VOL 3-2-B

VAMPIRE

MODIFICATIONS

TECHNICAL STAFF INSTRUCTIONS
INDEX SHEET.

DRG. NO. A.R. 4099 G P 16 57
SHEET 2

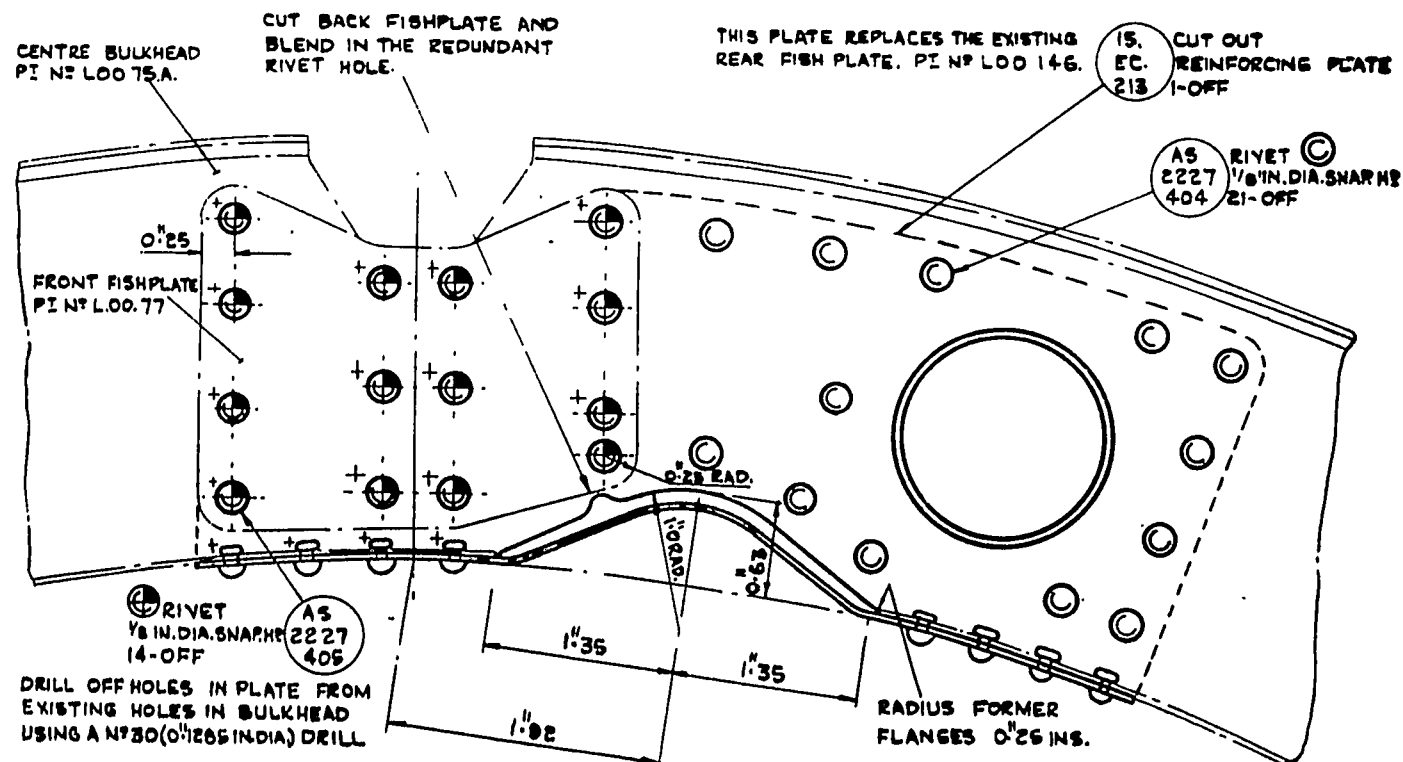
- (2) Trim the existing front fish plate, Part No. LOO.77A as shown on sheet 2 of the drawing rounding the corners with a 0.25 in. radius. Remove any sharp edges. Offer up the new cut-out reinforcing plate, Part No. 15.EC.213, to the rear face of the centre bulkhead, in the position shown, and drill off its eighteen rivet attachment holes in the bulkhead with the No. 30 drill, using the holes in the reinforcing plate as a guide. Drill off the remaining rivet attachment holes in the reinforcing plate from the existing holes in the bulkhead. Deburr all holes. Coat the mating surfaces of the new plate, the modified fish plate, and the bulkhead with pigmented varnish jointing compound (Ref. No. 33C/1264) and rivet these plates into position on the bulkhead using thirty-five $\frac{1}{8}$ in. dia. snaphead rivets, Part No. AS.2227/405 (fourteen off) and Part No. AS.2227/404 (Twenty-one off) the longer of these rivets being used for securing both the fish plate and the new reinforcing plate into position.

ORG. NE AR 4099 G P 16 57
SHEET 3

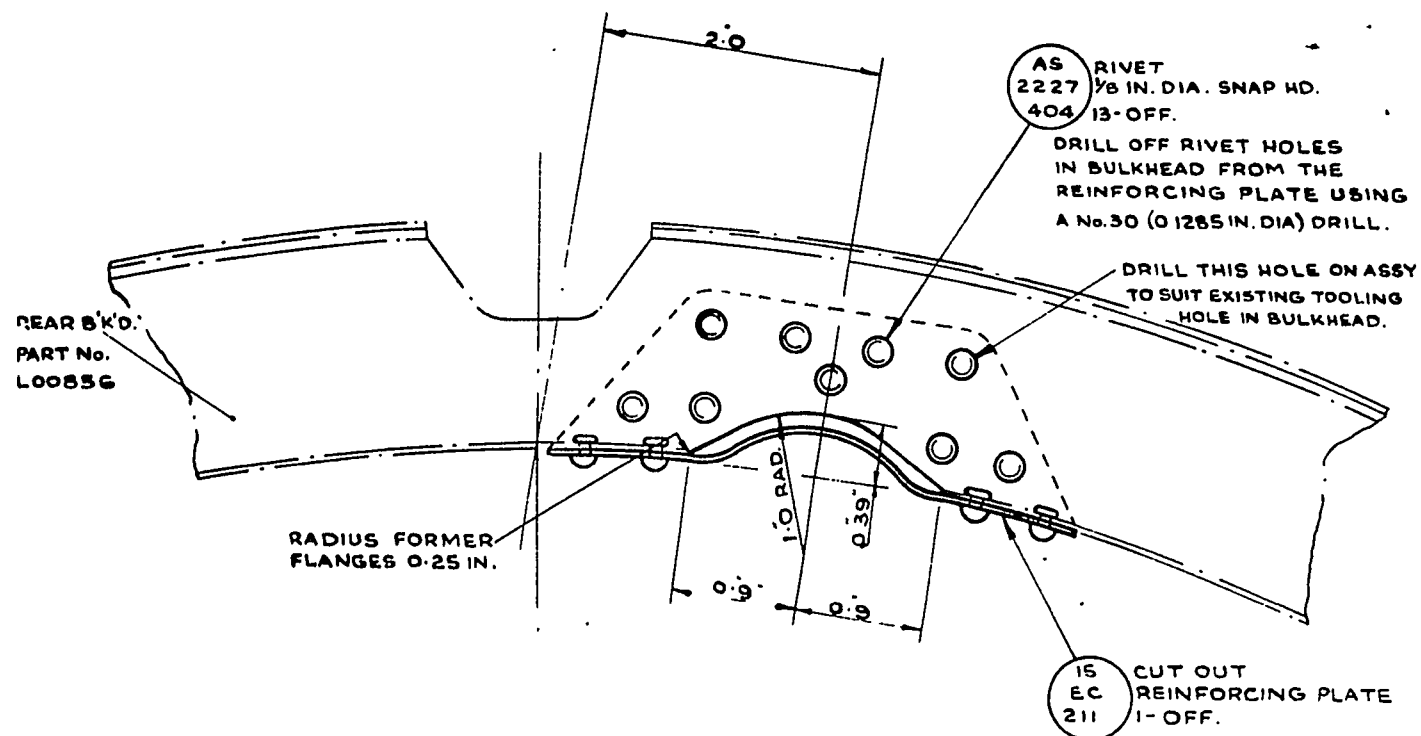
- (3) Locate the rear bulkhead Part No. LOO.856, in the tail cone, reference to Detail 'Y' sheet 1 of the drawing will show where it is situated. Refer to sheet 3 of the drawing, mark off and cut the cut-out to the measurements shown, removing any sharp edges. Place the new cut-out reinforcing plate, Part No. 15.EC.211 on the rear face of the bulkhead in the position shown and using the No. 30 drill, drill off the attachment rivet holes, using the holes in the reinforcing plate as guide.

DETAIL A

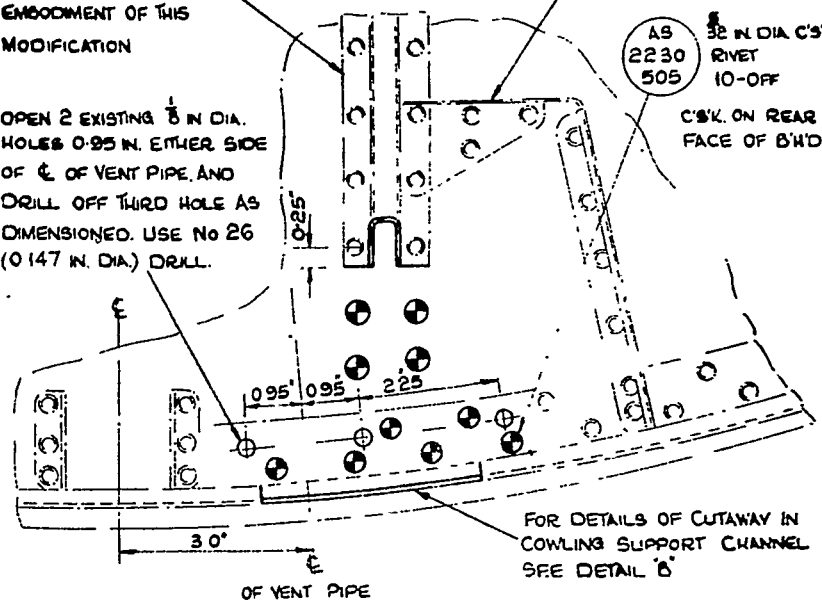
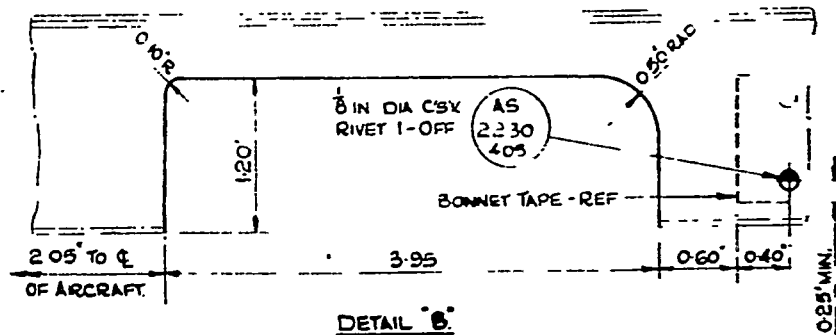
(3) Refer to "Detail 'A'" in Sheet 1 of the drawing. Drill out the first four rivets attaching the bottom of the vertical stiffener to the bulkhead, using a No. 30 drill. Cut back the vertical stiffener, as shown. Obliterate the old Part No. A00971ND (ref. only), and stamp the new Part No. A007353ND on the stiffener.

(4) Refer to "Detail 'A'" in Sheet 1 of the drawing. Mark, cut and file the cutaway for the relief valve assembly in the cowling support channel. Cut back the bonnet tape and drill one hole, using a No. 30 drill. Attach the tape to the cowling support channel with one rivet, Part No. AS.2230/405.

(6) Open up the two existing holes, previously used for rivets attaching the redundant vent assembly to the bulkhead, and drill out the third hole as shown in "Detail 'A'" in Sheet 1 of the drawing, using a No. 26 (0.147 in. dia.) drill.

(7) Refer to "Detail 'A'" in Sheet 1 of the drawing. Drill out the six $\frac{3}{8}$ in. dia. rivets attaching the cowling support channel to the bulkhead, where shown, using a No. 30 (0.1285 in. dia.) drill. Open up the six holes and the four redundant holes previously used for rivets attaching the stiffener to the bulkhead with a No. 21 (0.159 in. dia.) drill. Countersink these ten holes 120 deg. to a depth of 0.045 in. and fill up with ten rivets, Part No. AS.2230/505.

FIG. 1.
INSTALLATION OF PLUG, SOCKET ON BULKHEAD 1.

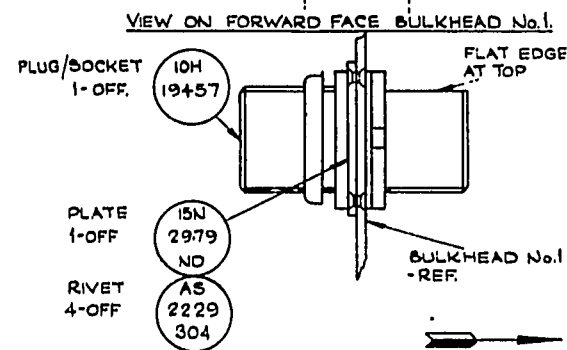
- (6) Refer to fig. 1 on sheet 18 of the drawing, and manufacture the plate, Part No. 15N.2979ND, as detailed using 16 s.w.g. aluminium-alloy sheet, Spec. B.S.L.72 (Stores Ref. 30B/1728). Refer to fig. 1 on sheet 1 of the drawing and enlarge the existing bulkhead connector hole to the new dimensions as detailed, and where the new cut-out line breaks into any existing holes the badly shaped edges are to be blended out. Deburr the hole removing any sharp edges.

- (7) Refer to fig. 1 of sheet 1 of the drawing and insert, from the aft face of the bulkhead, the new bulkhead connector (Stores Ref. 10H/19457). Ensure that the locating pins are correctly engaged and then tighten and secure the connector in position.

FIG. 2. INSTALLATION OF No. 1. INVERTER
(VIEW LOOKING FROM STARBOARD)

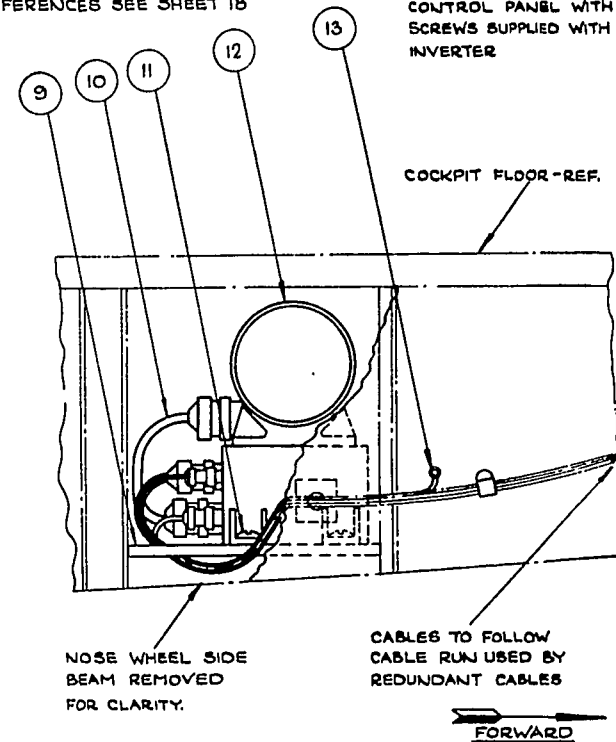
(17) Refer to fig. 2 of sheet 1 of the drawing and assemble the control panel type 12 to the inverter, type 100A (Stores Ref. 5UB/4938) using the attachment items supplied with the inverter. Secure the support channels, Part Nos. 15-22N.131A (port); 15-22N.129A (starboard), to the control panel, using four $\frac{1}{4}$ in. B.S.F. bolts, stiffnuts and washers, Part Nos. AS.1246/5E, AGS.2001/E1 and SP.13/E respectively, having first coated the mating surfaces with pigmented varnish jointing compound. Connect the new cable assembly, Part No. 12-20N.1099A, between the inverter and control panel, and secure the complete unit to the support brackets from which the redundant unit was removed in operation (5), using the retained attachment items.

(18) Route and connect the earth cable to the earth bolt on the nose wheel side beam, as shown on fig. 2 on Sheet 1 of the drawing. On final connection of the earth cable, brush coat the earth bolt and surrounding area, approximately one inch, with synthetic bright blue identification colour, Spec. D.T.D.826 (Stores Ref. 33B/1076 or 1007).

FIG. 1. PLUG BRACKET-VIEW FROM REAR

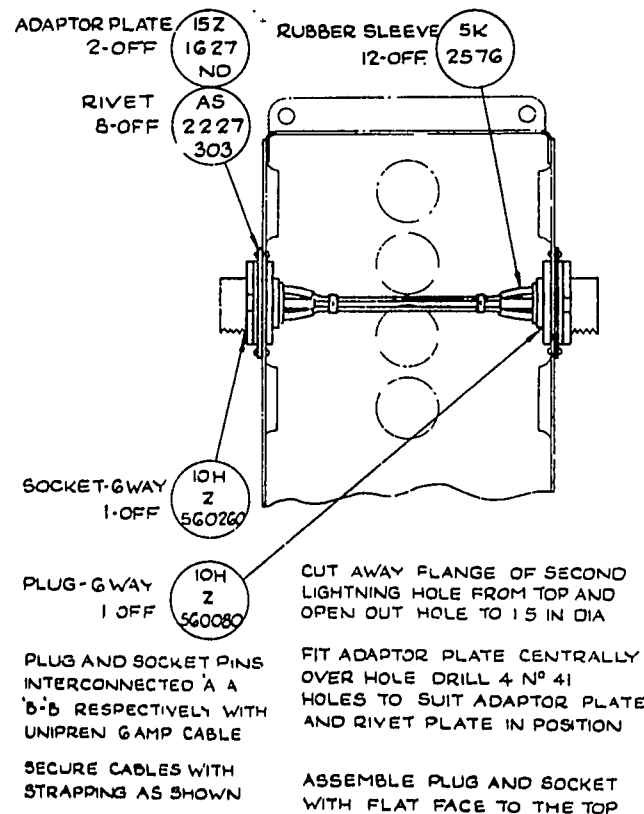
(23) Working on the plug bracket, Part No. 15-N.915, removed in operation (3), and referring to fig. 1 and Sheet 3 of the drawing, cut away the flange from the two lightning holes located second from the top. Open out the holes to 1.5 in. dia. and position two adaptor plates, Part No. 15-Z.1627ND, centrally over the outside of each hole, with the squared section of the holes to the top. Drill eight No. 41 (0.0960 in. dia.) holes in the plug bracket to mate with four holes pre-drilled in each of the plates. Remove the plates and deburr the holes. Coat the mating surfaces of the plug bracket and adaptor plates with pigmented varnish jointing compound and then rivet the plates in position, using eight 3/32 in. dia. snaphead rivets, Part No. AS.2227/303.

(24) Refer to fig. 1 on Sheet 3 of the drawing, and link together the new plug and socket (Stores Refs. 10H/Z.560080 and 10H/Z.560260 respectively), with six 4½ in. lengths (approximately) of unipren 6 amp electric cable, spec. B.S. E.21 (Stores Ref. 5E/3038). The link cables are to be connected 'A-A', 'B-B', 'C-C', 'D-D', 'E-E', 'F-F', respectively, and coded at each end, using type 'B' 2 mm. marking sleeves assembled on twelve rubber binding sleeves (Stores Ref. 5K/107065). Strip back the insulation from each end of the cables 0.13 in., and solder them to their respective pins, using resin cored electricians' solder. Slide the rubber sleeves over the soldered joint and then assemble the plug and socket to the plug bracket, the flat surface being at the top as shown on the drawing. Secure the cables as shown, with strapping and studs.

FIG. 1 INSTALLATION OF FERRULES FOR BOX 'K'

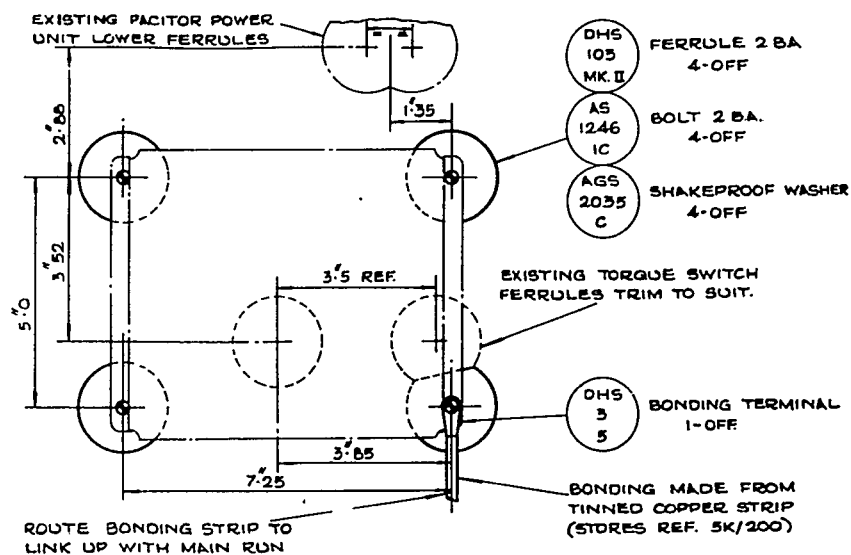
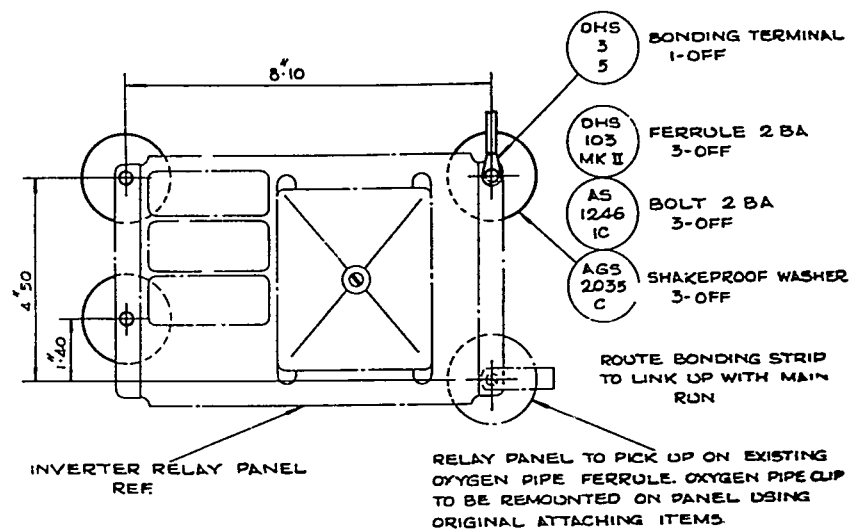
(28) Refer to fig. 1 and fig. 2 on Sheet 4 of the drawing and mark off the positions on the starboard cockpit wall for the inverter relay panel and box 'K' ferrules. Using a standard 0.75 in. 'Fosner' or 'Wilpat' bit, counterbore to a depth of 0.43 in. at each of these positions.

(37) Refer to fig. 1 on Sheet 4 of the drawing and offer up and secure in position box 'K', using four 2 B.A. bolts and shakeproof washers, Part Nos. AS.1246/1C and AGS.2035/C respectively. Secure the bonding terminal in position, as shown, having first removed the finish from the mating surface of the box to ensure a good electrical contact. Coat the bolt, terminal and surrounding area of the box from where the finish was removed with synthetic bright blue identification colour. Next blank off plug 'K5' on box 'K' using a small end cover (Storef Ref. 10H/Z.970055).

SHEET 7

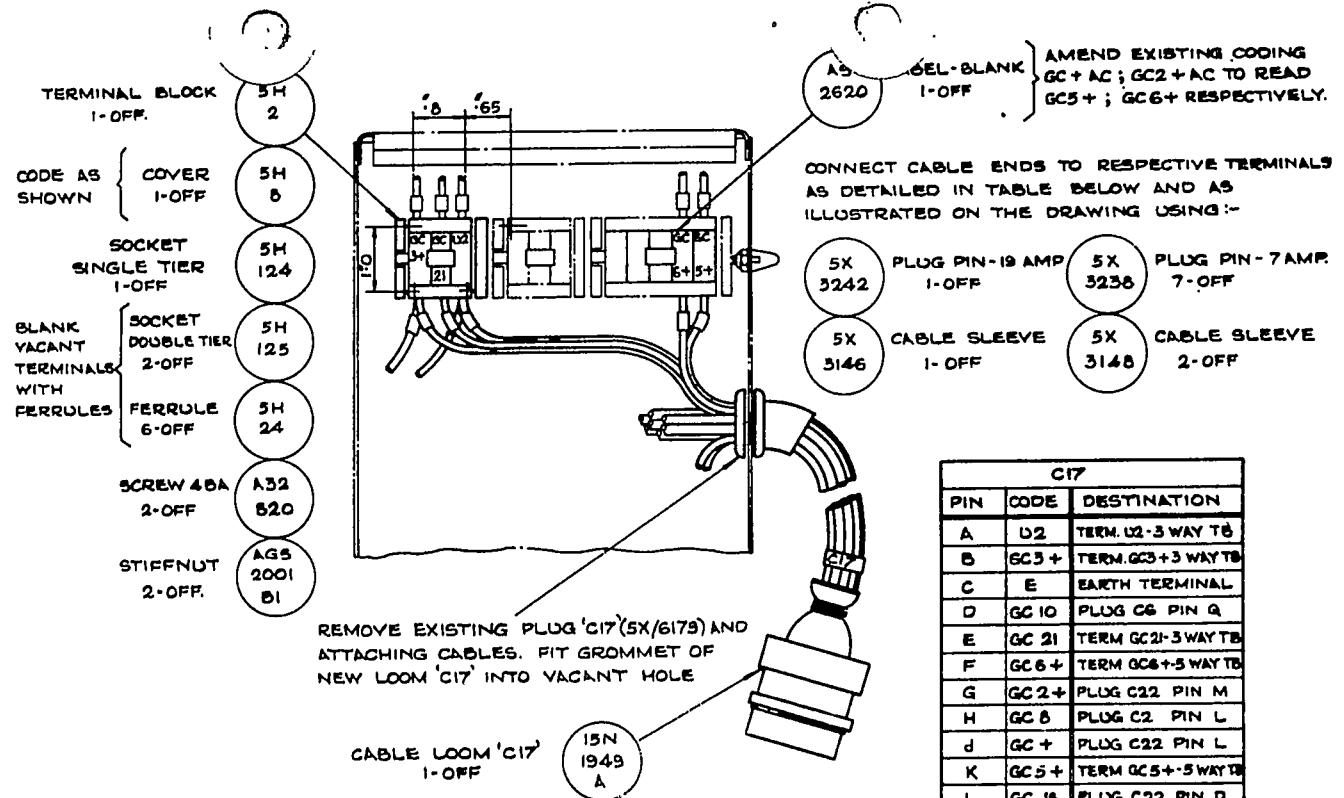
(40) Refer to Sheet 7 of the drawing, mark off the attachment points of the new three-way terminal block (Stores Ref. 5H/2), and drill two No. 26 (0.1470 in. dia.) holes. Deburr the holes and clean from the box any swarf or filings, then secure the terminal block in position, as shown, using two 4 B.A. screws and stiffnuts, Part Nos. A.32/B20 and AGS.2004/D1 respectively. Attach to the centre section of the terminal block one single tier socket (Stores Ref. 5H/124) and to the two remaining sections two double tier sockets (Stores Ref. 5H/125). Code the new terminal block cover (Stores Ref. 5H/8) as shown on the drawing.

(46) Working inside junction box No. 3 and referring to Sheet 7 of the drawing, replace the label of the five-way terminal block shown, with a new blank label, Part No. AS.2620, coded as shown with marking ink.

(47) Refer to Sheet 7 of the drawing and connect the new cable loom 'C17', Part No. 15-N.1949A, to the junction box, routing it into the panel through the hole left vacant by the redundant socket 'C17', removed in operation (39). Connect the appropriate cables of the new loom to the terminal blocks and blank off all vacant socket entries, using six ferrules (Stores Ref. 5H/24). Connect the remaining cables to their respective points of termination, using seven 7 amp. and one 19 amp plug pins (Stores Refs. 5X/3238 and 5X/3242 respectively); two 4 amp cable to 7 amp pin cable sleeves (Stores Ref. 5X/3148) and one 7 amp cable to 19 amp pin cable sleeve (Stores Ref. 5X/3146).

FIG. 1. INSTALLATION OF CIRCUIT BREAKERS ON INSTRUMENT PANEL.

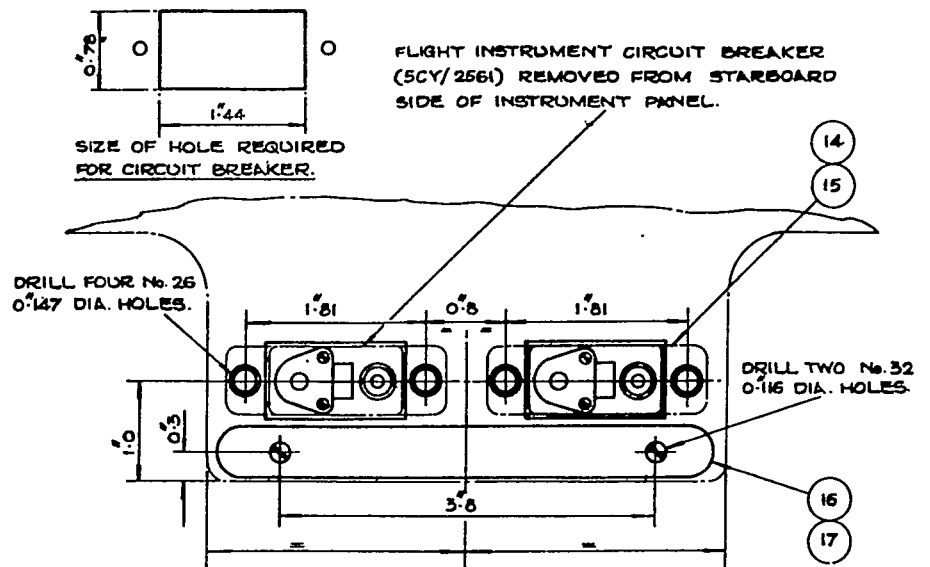
(61) Refer to Sheet 11 of the drawing and disconnect, remove and retain the flight instrument circuit breaker (Stores Ref. 5CY/2561), from the starboard side of the instrument panel. Blank off the redundant circuit breaker aperture with a cover plate, Part No. 13-N.399, secured in position with two 4 B.A. bolts and stiffnuts, Part Nos. AS.1246/1B and AGS.2001/B1 respectively.

(64) Refer to Sheet 11 and fig. 1 on Sheet 12 of the drawing and mark off, cut-out and drill the holes detailed for the No. 1 and No. 2 inverter circuit breakers and label. Deburr the holes. Offer up and secure in position the label, Part No. 15-N.1931, using two 6 B.A. brass screws, washers and stiffnuts, Part Nos. A.44/A14, SP.22/A and AGS.2001/A4 respectively.
